From: [REDACTED]
To: [REDACTED]
CC: [REDACTED]
Sent: 2/23/2021 2:35:29 PM
Subject: RE: O8W-PM 35217268, 35224712, 35224713 - Bucks Creek 1101 Phase 1,2&3 - Pre-Engineering Meeting
Importance: High

Bucks Creek 1101- PM# 35217268 Overview Map

Subject: O8W-PM 35217268, 35224712, 35224713 - Bucks Creek 1101 Phase 1,2&3 - Pre-Engineering Meeting

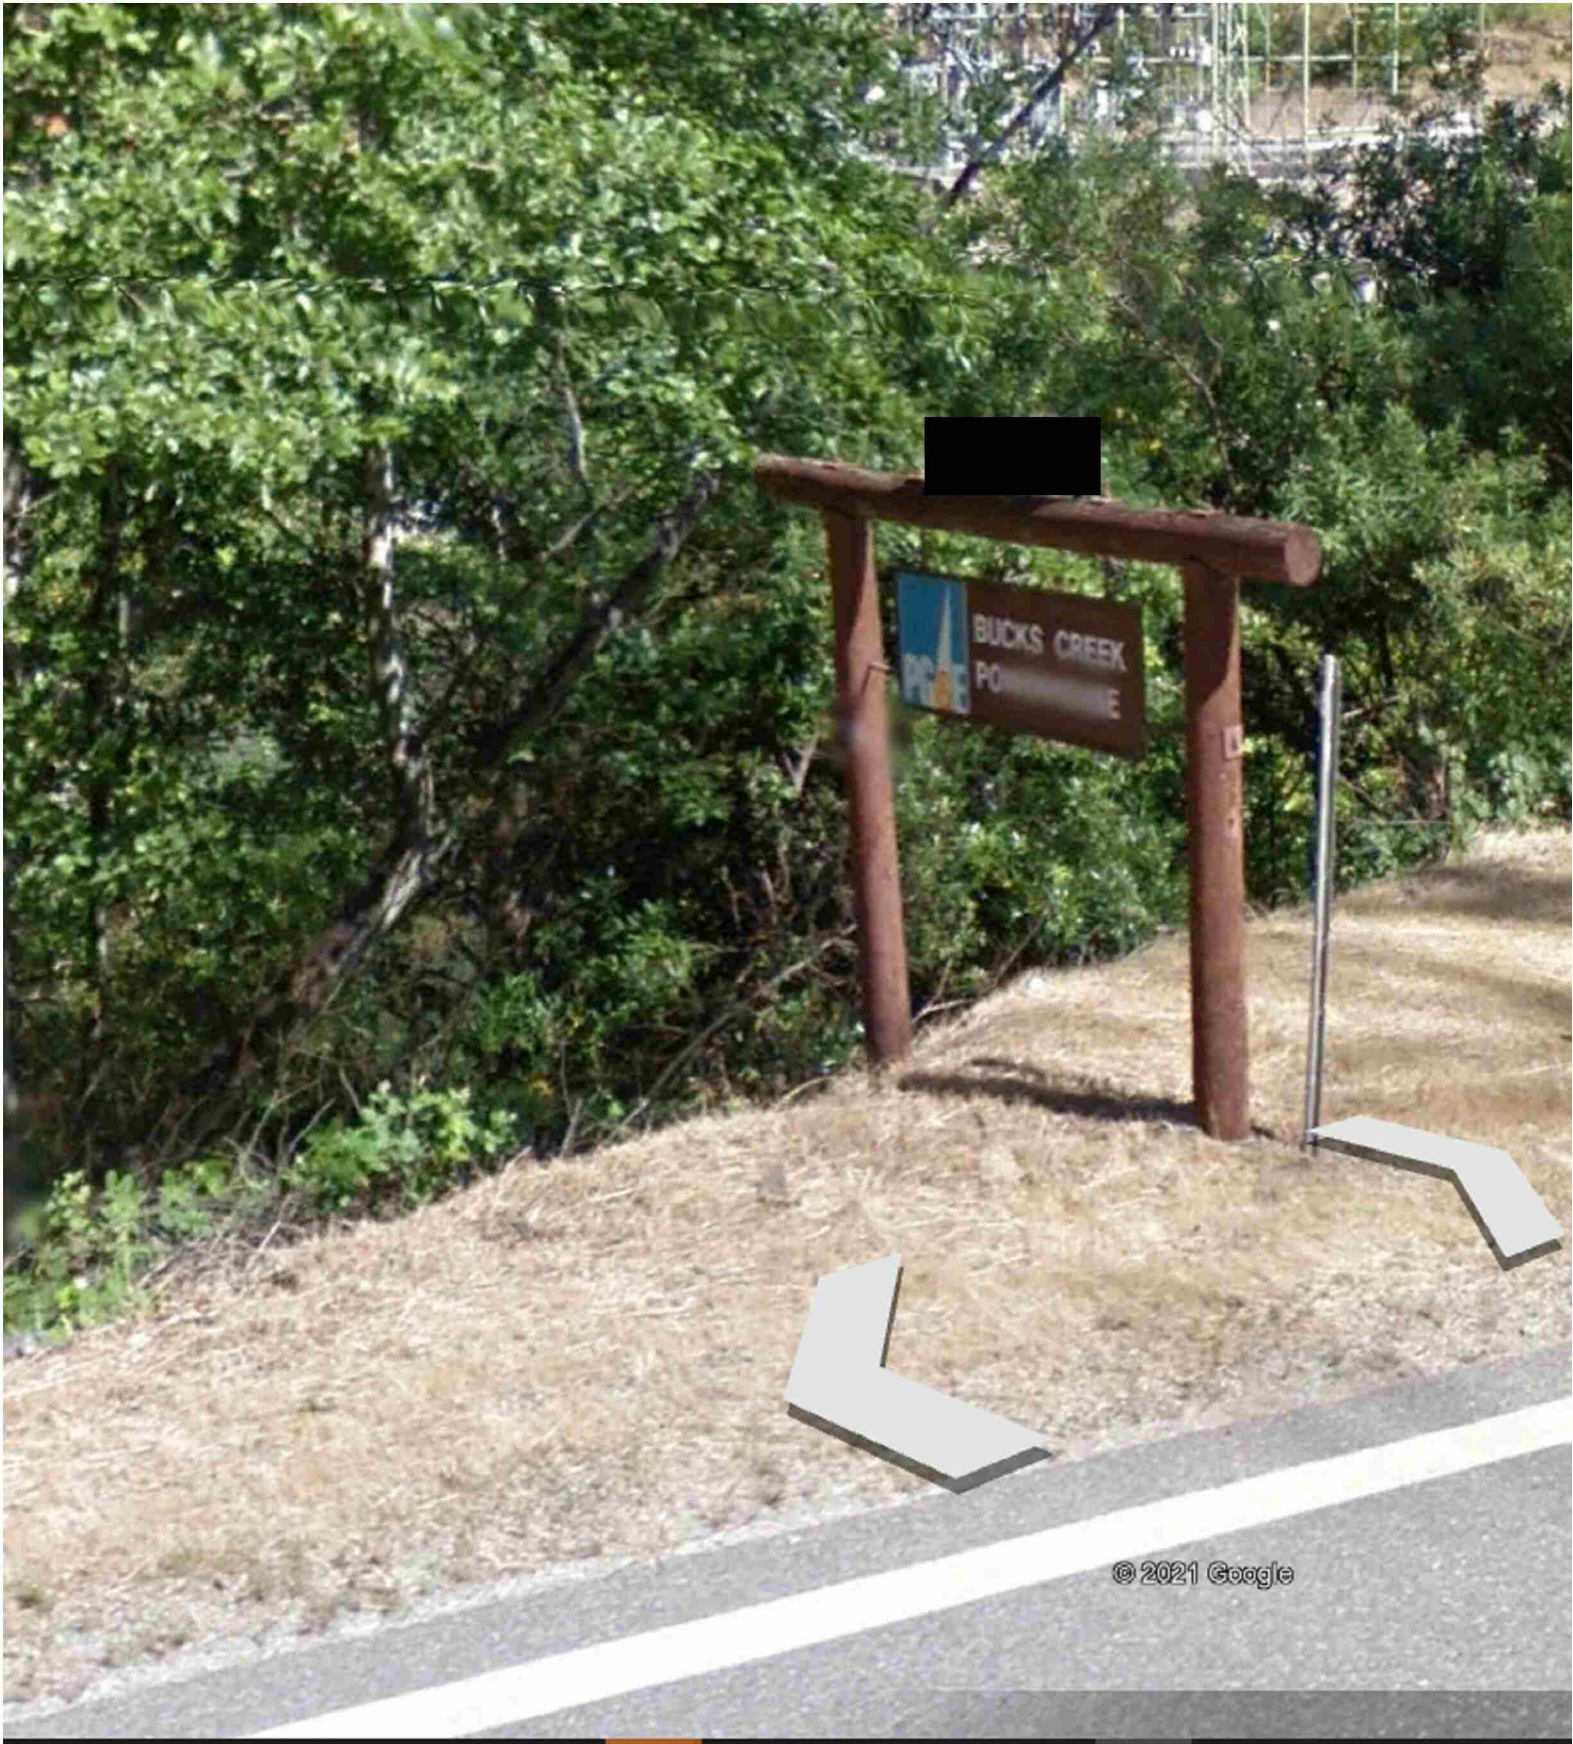
Attached are the 'base-map' limits in a kmz. file. As you will see, we need our base-map to go about ~100' into the tunnel at the south end (see pedestal in picture below....please begin about ~50 beyond this point which is about ~100' beyond the Cresta Dam).

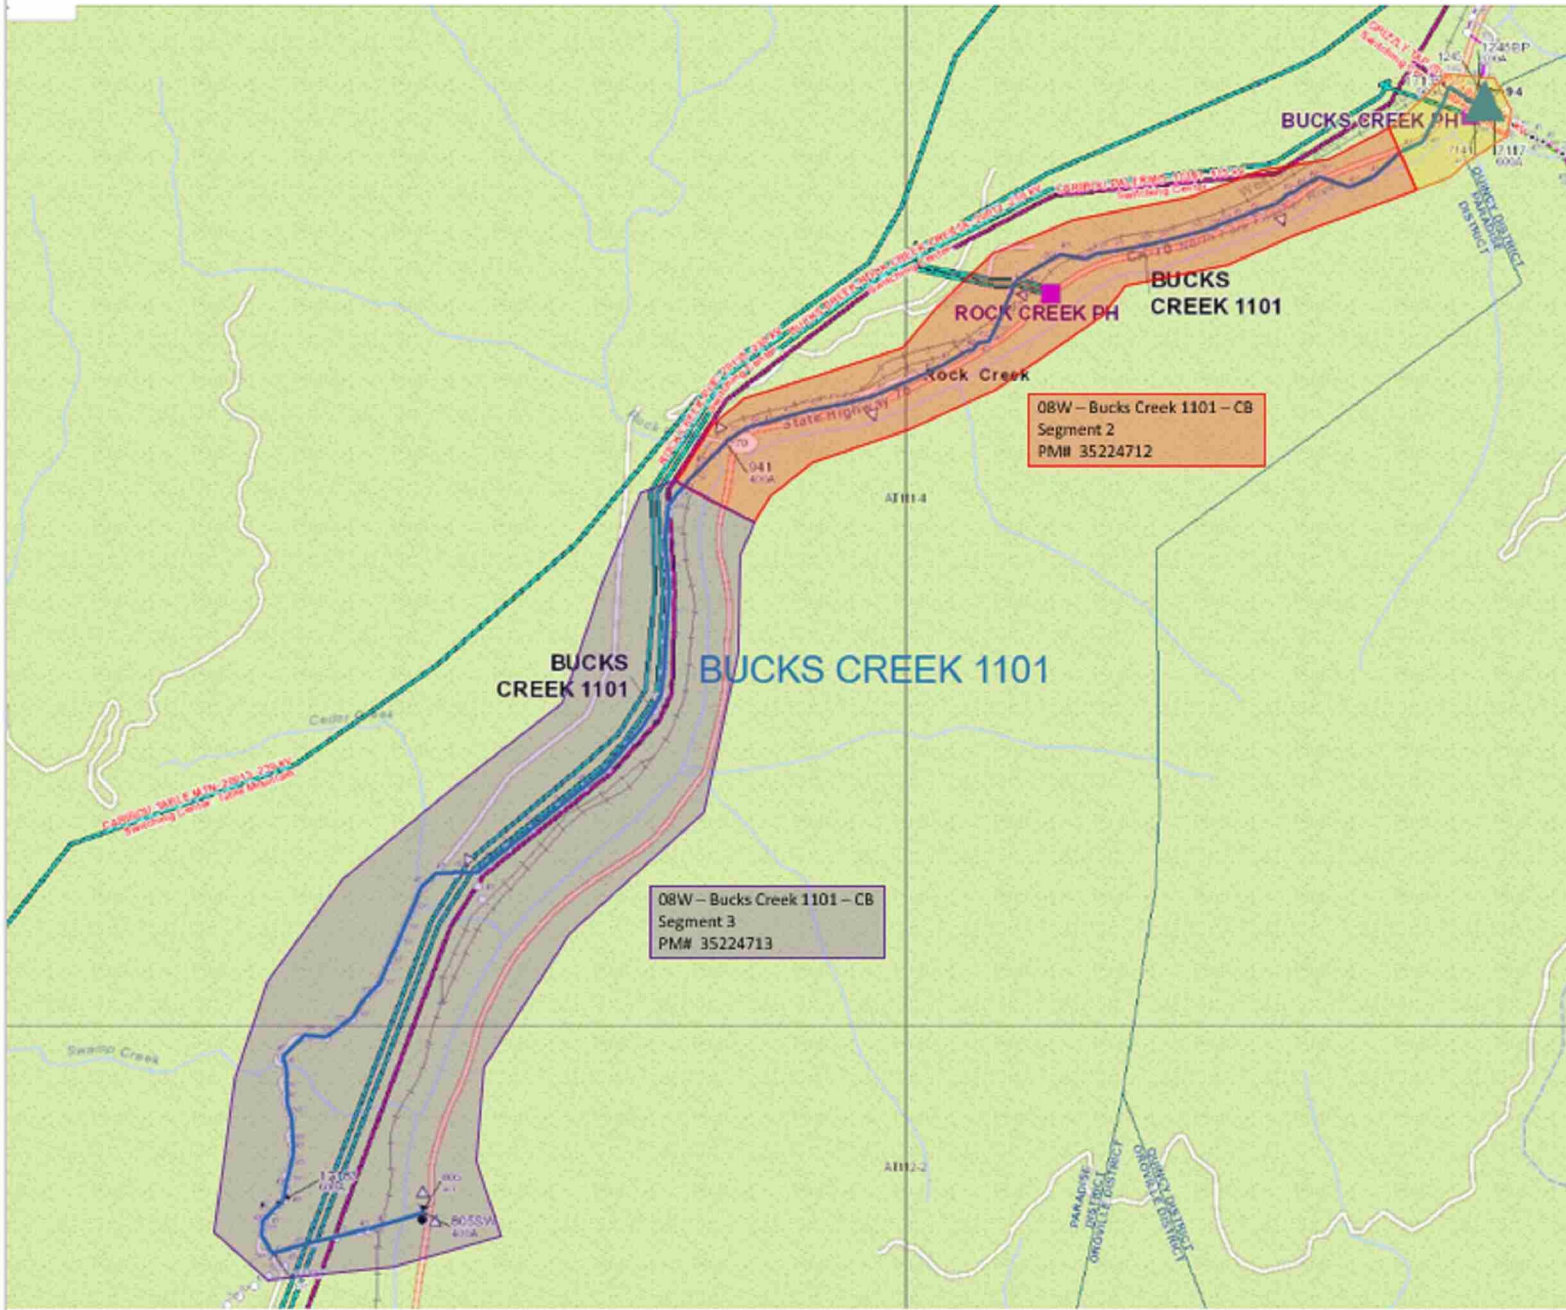
We want to end the base-map at the sign location below which is roughly at MM (Mile Marker) 5.10.
